NORTHEAST MAINTENANCE SUBSTATION ADDITION TO WICHITA, SEDGWICK COUNTY, KANSAS

RE: S/D- 98-93 - Final Plat of NORTHEAST MAINTENANCE SUBSTATION ADDITION

STAFF REPORT
(One-Step Final Plat)

CASE NUMBER: S/D 98-93 - NORTHEAST MAINTENANCE SUBSTATION ADDITION

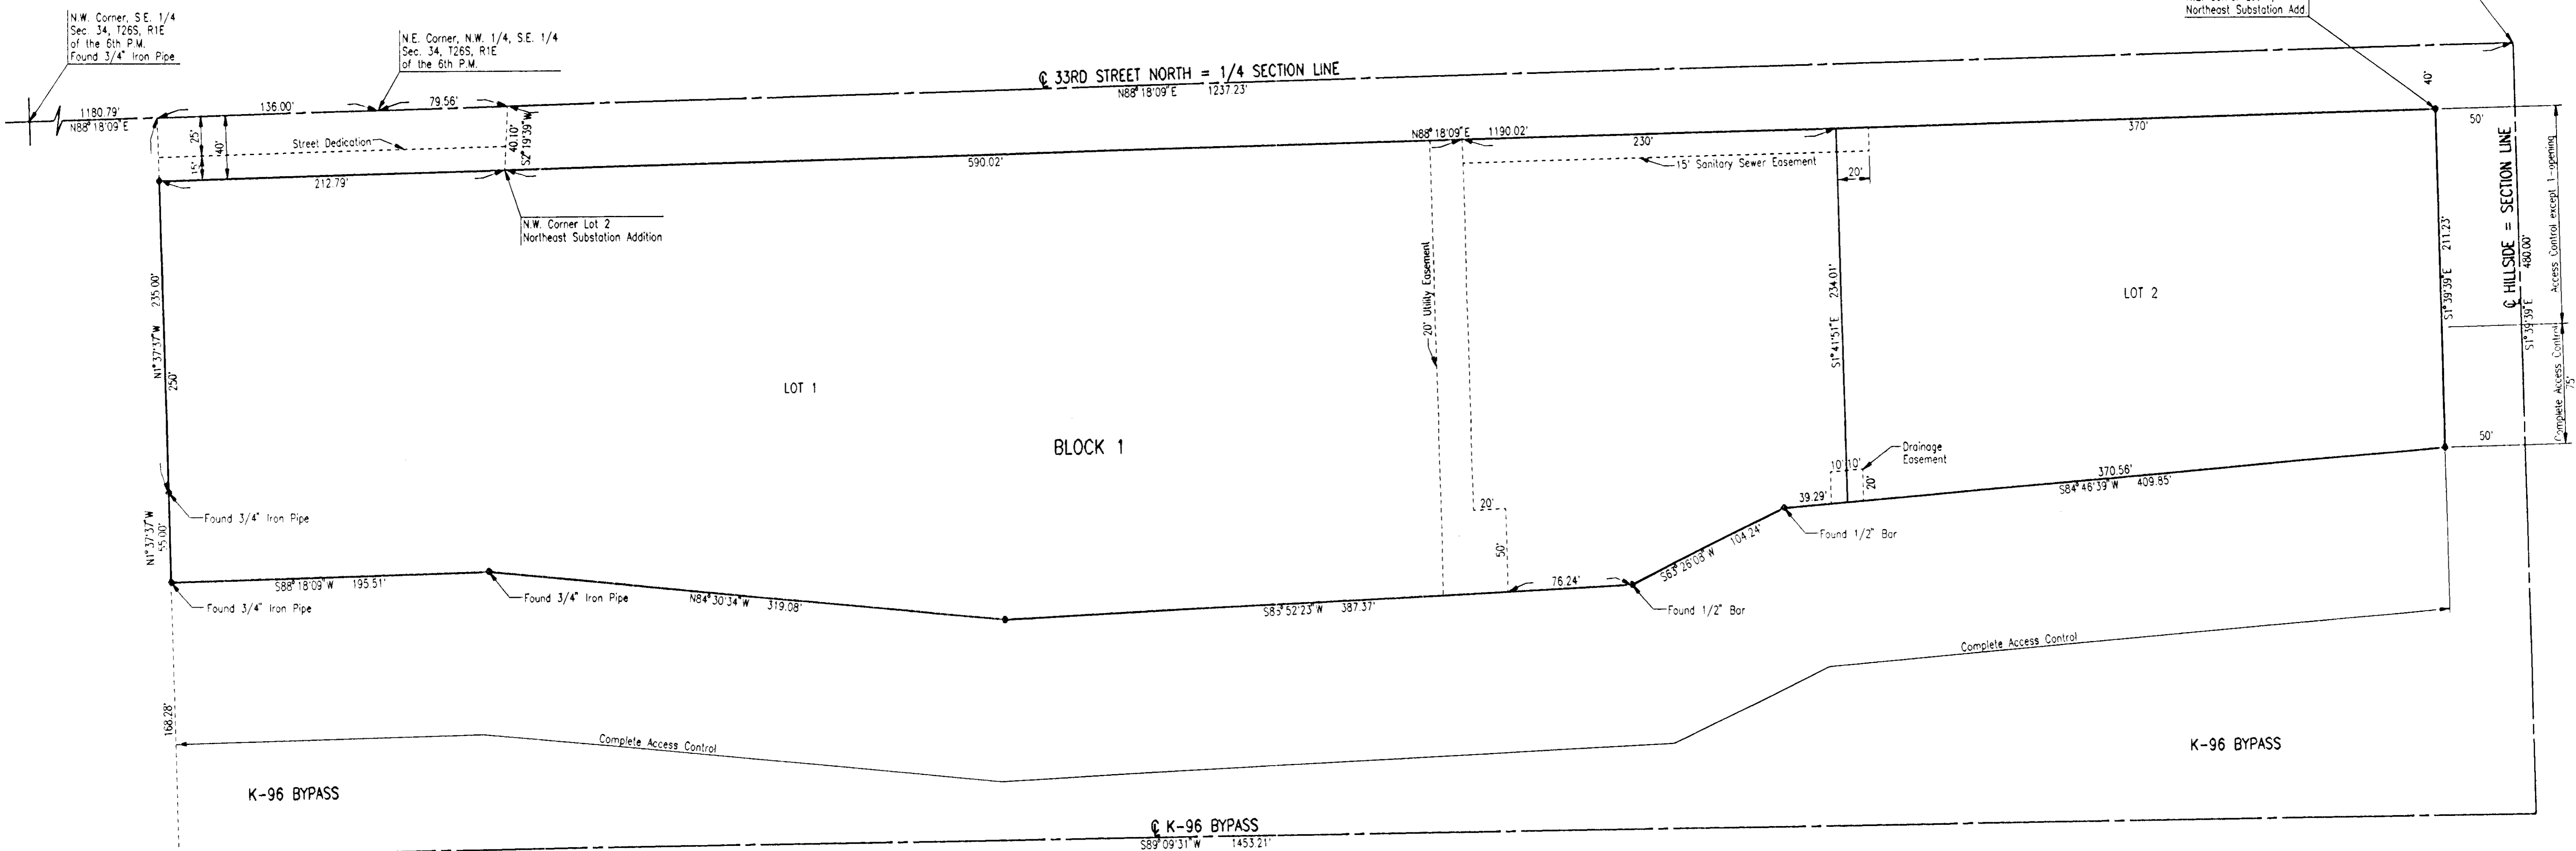
- A. Existing municipal services appear to be available to serve this site. City Engineering needs to verify if any other additional guarantees are required. *A guarantee needs to be provided for sanitary sewer extension to Lot 2.*

- C. City Engineering needs to comment on the status of the applicant's drainage plan. *A cross-lot drainage agreement needs to be established by separate instrument.*

- D. Traffic Engineering needs to comment on the platted access controls. The plat denotes one access opening along Hillside. Access controls dedicated along K-96 need to be referenced on the final tracing.

- E. Since drainage occurs onto K-96, a letter shall be provided from KDOT indicating their agreement to accept such drainage.
- F. The dedication of right-of-way for 33rd St. North needs to be referenced in the plat's text.

- N. Perimeter closure computations shall be submitted with the final plat tracing.
- O. Recording of the plat within thirty (30) days after approval by the City Council and/or County Commission.
